From: Jack Dawley <jdawley@northlandresidential.com>
Sent: Thursday, December 16, 2021 11:09 AM
To: Hummel, Robert; Santos, Michael
Cc: Giles Ham (gham@rdva.com); Jack Dawley
Subject: [EXTERNAL]FW: 8058 - Speed, Sight Lines and Stop Signs - McLean District project - Belmont MA
Attachments: Conceptual Improvements Plan.pdf; VHB sight distances plan.pdf; Sight Line Pictures.pdf
Importance: High

As requested, VAI has reviewed the sight distances for vehicles exiting the chapel drives along Olmsted drive. The attached graphic prepared by VHB depicts the available and required sight distances. Coming down the hill at the driveways there is a 3% downgrade with a required sight distance of 158 feet. The available sight distance is in excess of this requirement. Coming up the hill there is an approximate 9% upgrade and only 140 feet is required and is

SIGN LEGEND	
R1-1	
R1-4	
R2-1	
W3-1	
W11-2	
W16-7P

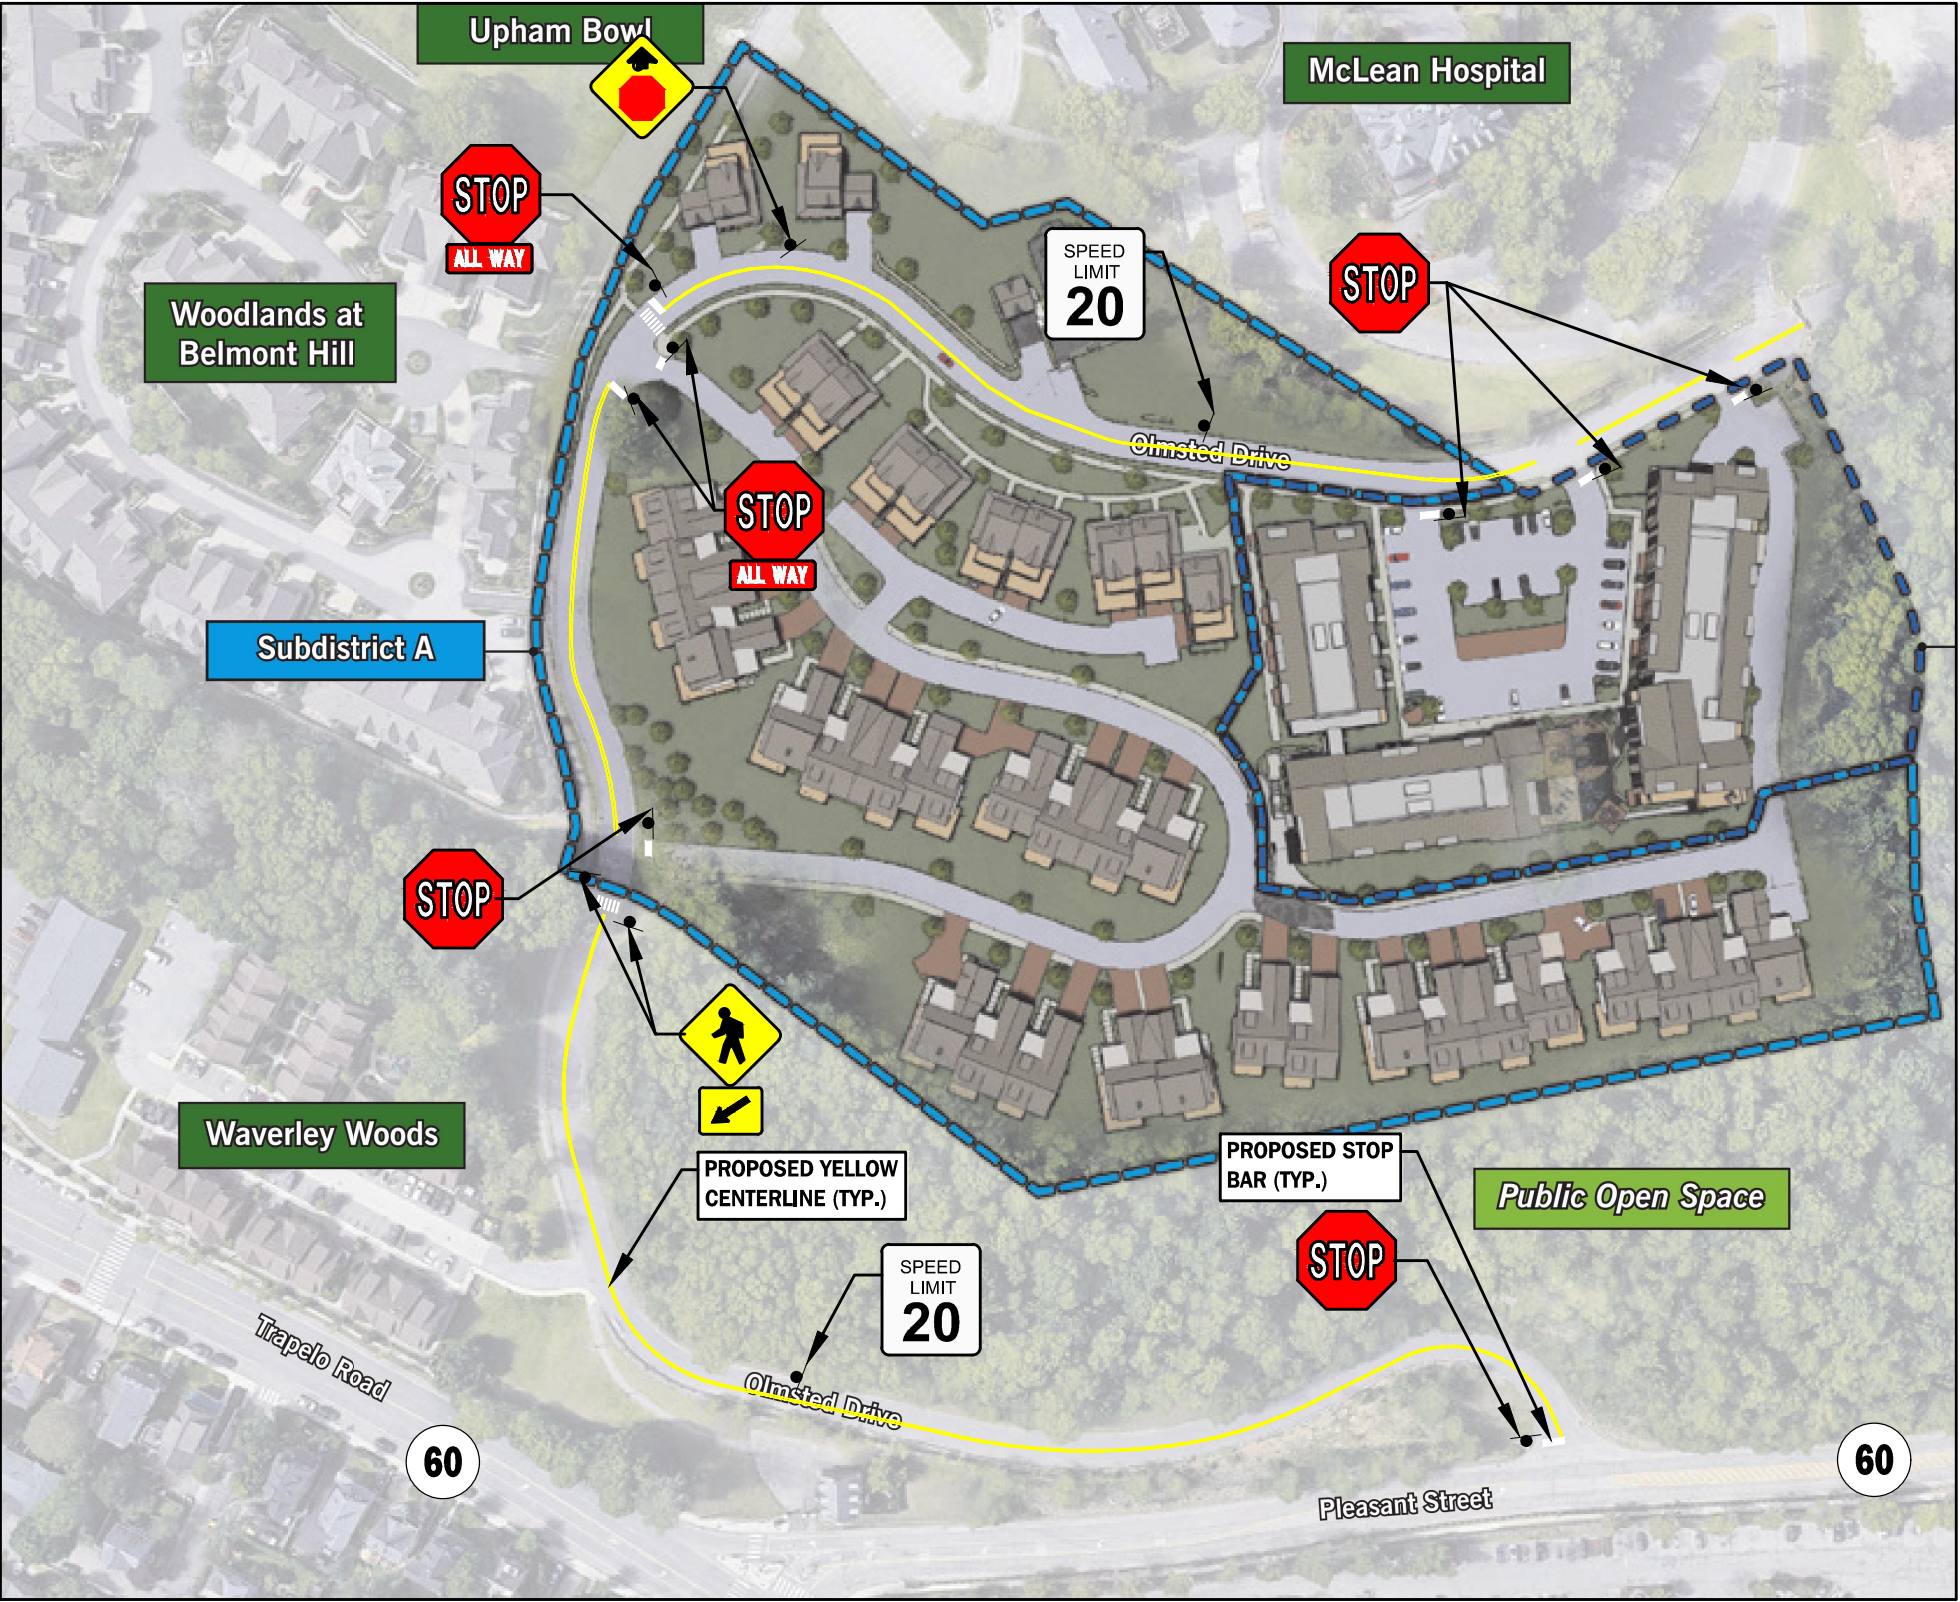
Also attached is an updated signage plan for the project. We have added additional safety enhancement signage to the plan. The new signs include a 3-way stop at the site driveway, 20 MPH speed limit signs and pedestrian signs.

Design Stopping Sight Distance on Grades

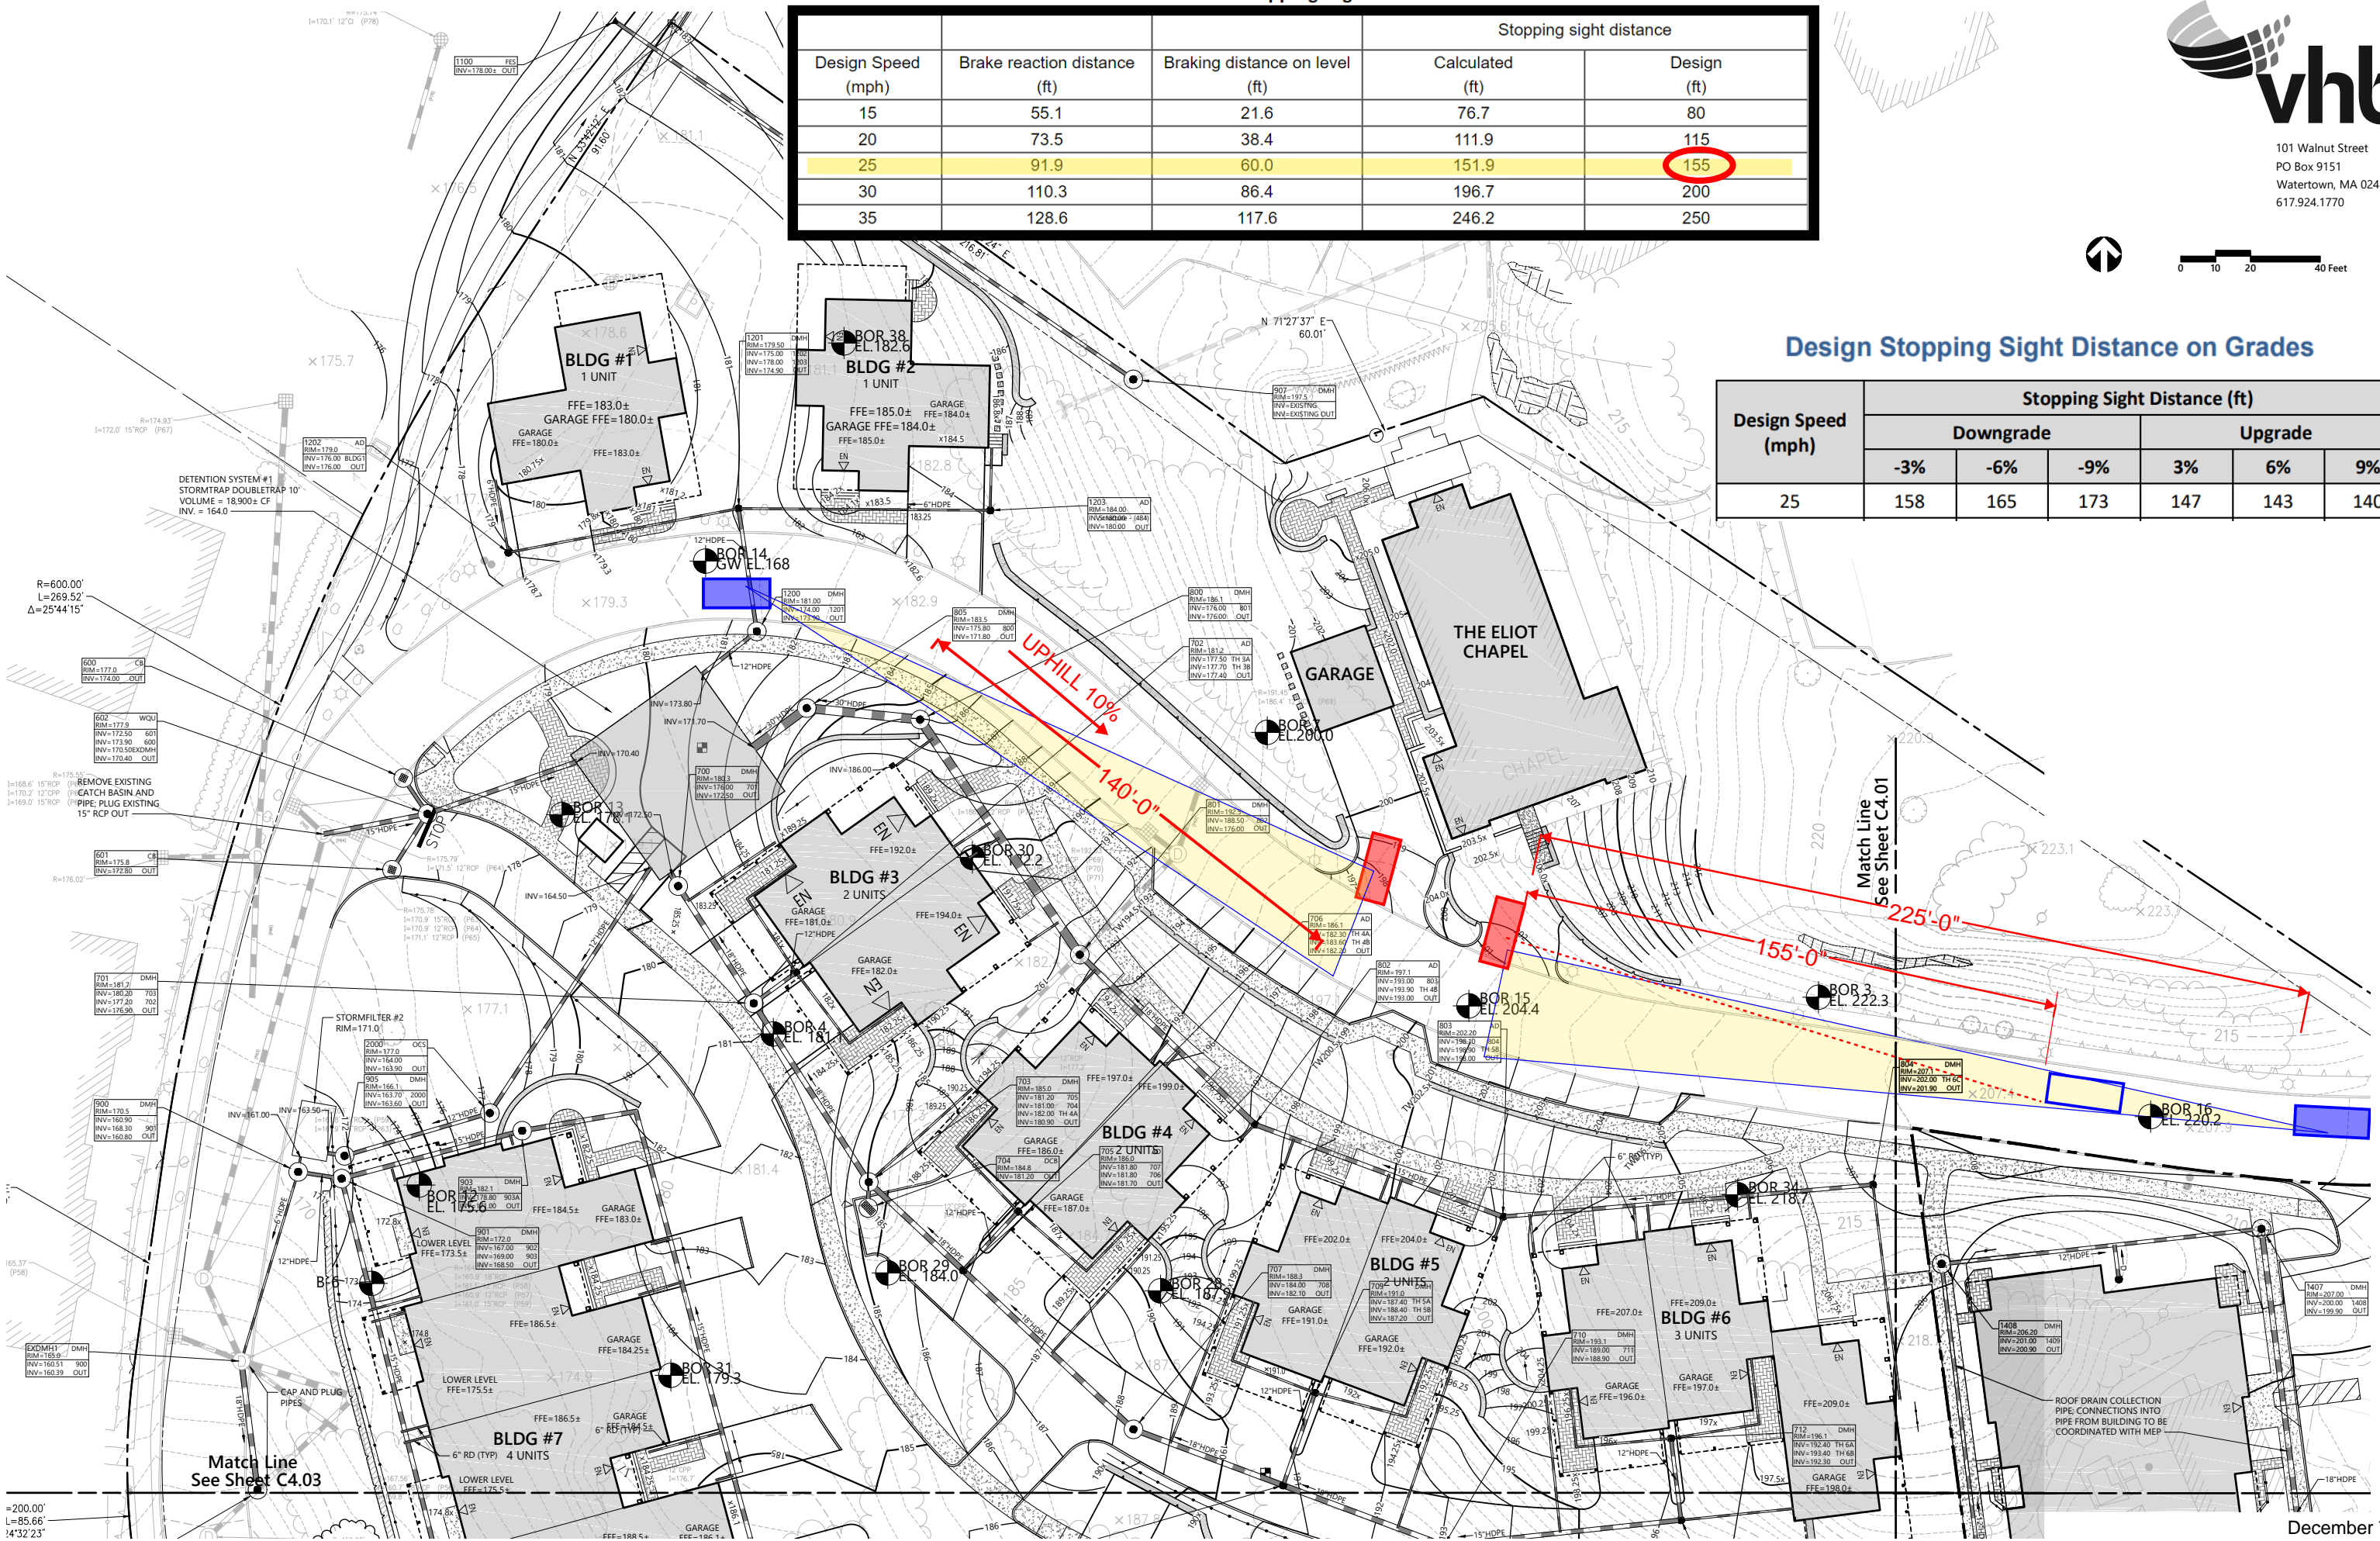
provided. We have also attached 2 pictures which depict the view of a vehicle exiting the driveway either forwards or backwards from 160 feet.
